Subject: Vehicle Updates to Prevent Damage Due to Mis-Installed Headlamp Bulbs

**Models Affected: All Freightliner New Cascadia vehicles built in
model years 2017 through 2020 with optional halogen headlamps**

Work Instructions

Fig. 1, Hood-Mounted Splash Shields Hole Locations

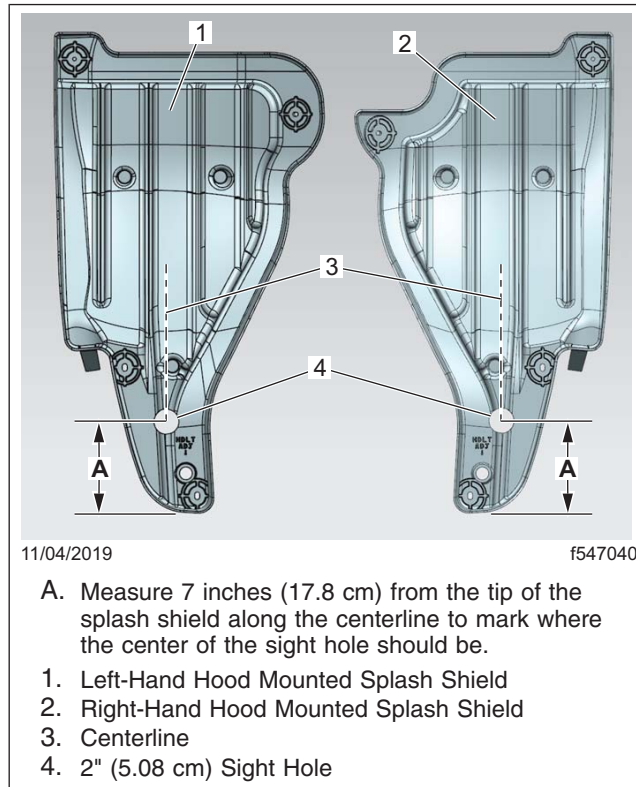
3. Using a hole saw, cut a 2" (5.08 cm) sight hole in each of the hood-mounted splash shields. This is to enable easier viewing of the outboard (low-beam) bulbs and to help with verifying proper installation. See [Fig. 1](#) and [Fig. 2](#).

Fig. 6, Inserting the Foam Grommet

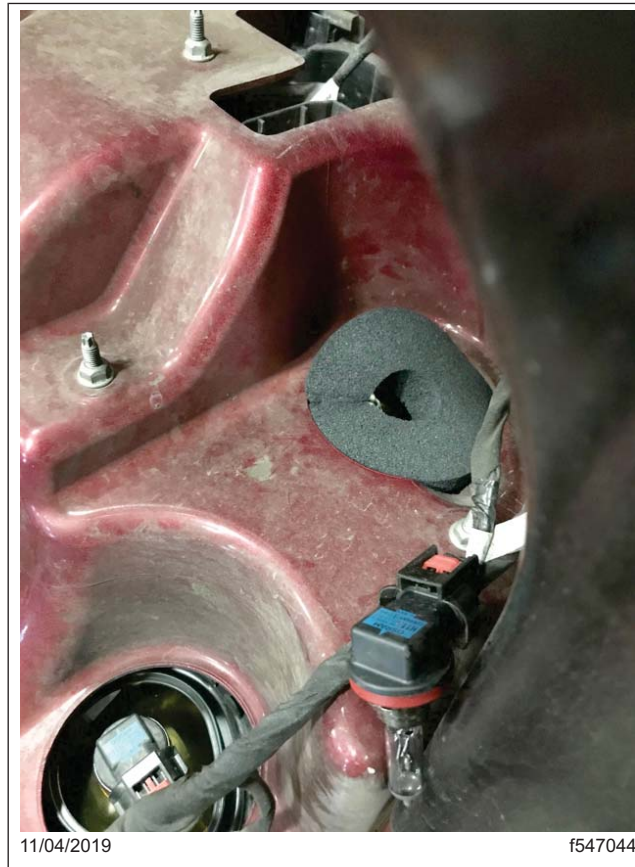
- 4.4 Insert the foam grommets into the headlamp housings. Push all edges inside the housing and ensure the foam does not interfere with the bulb mounting interface. See [Fig. 6](#) and [Fig. 7](#).

Fig. 10, Left-Hand Warning Label and Location (Right-Hand Similar)

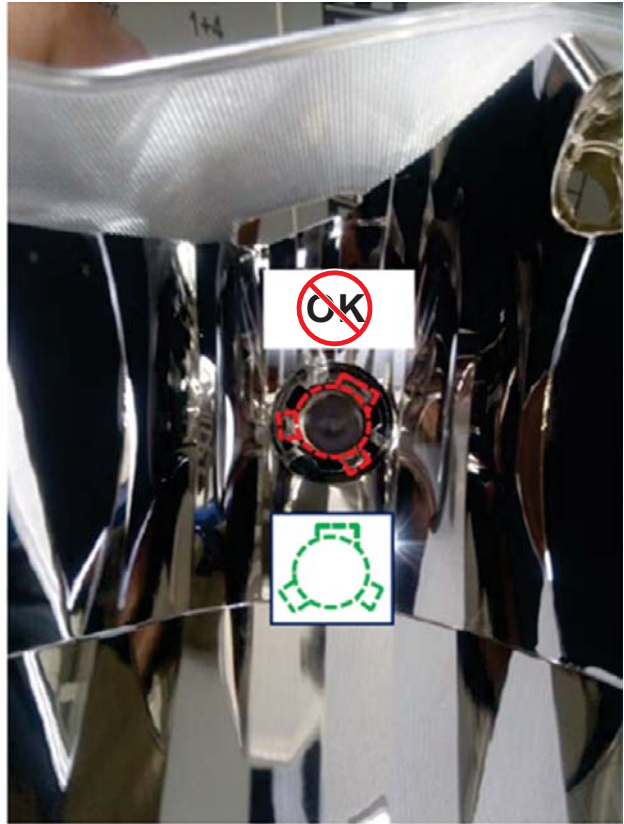
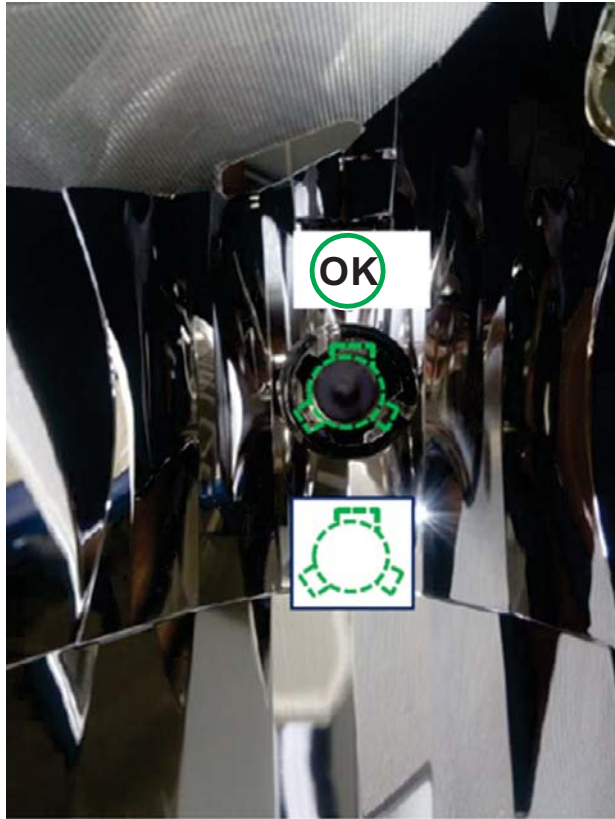
5. Clean two spots and install the warning labels (part number 24-02029-000) on each side of the hood. See [Fig. 10.](#)
